Intel[®] 5100 Memory Controller Hub Chipset

Specification Update

Revision 010US

Order Number: 318385-010US

41. Incorrect CKE behavior during recovery from S3 suspend

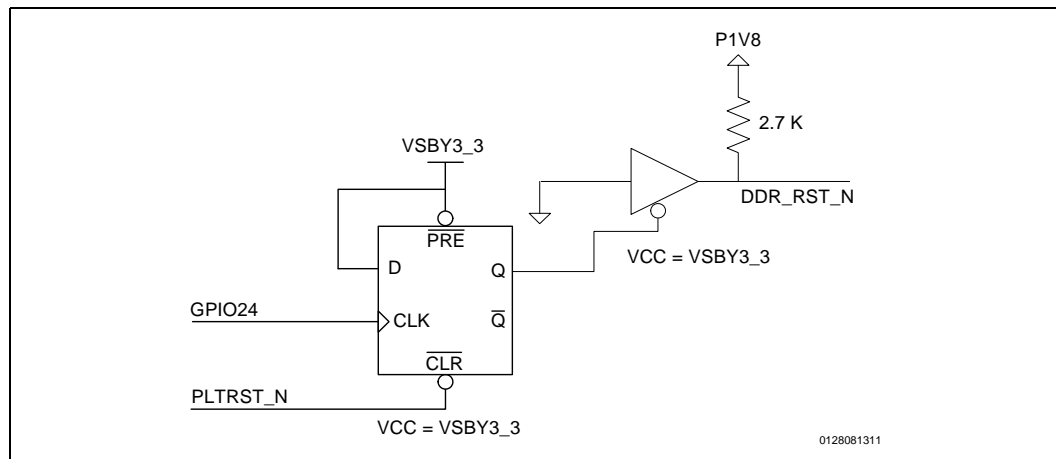
Problem: During the initial stage of exit from System Sleep State “S3” (suspend to RAM), the CKE signal is driven to an indeterminate state (High, Low, or tristate).

Workaround: The workaround requires both a board-level circuit and a BIOS change. The workaround holds the DIMMs in reset using a flipflop clocked by a GPIO from the ICH9R under control of the BIOS. An output controlled buffer is also required to transition the 3.3 V output of the flipflop to the 1.8 V reset input of the DIMM (see diagram below). The possible GPIOs are GPIO[28,27,24,12]. The GPIO implemented in the circuit is incorporated into the BIOS as a build option by an Intel BIOS Vendor (IBV).
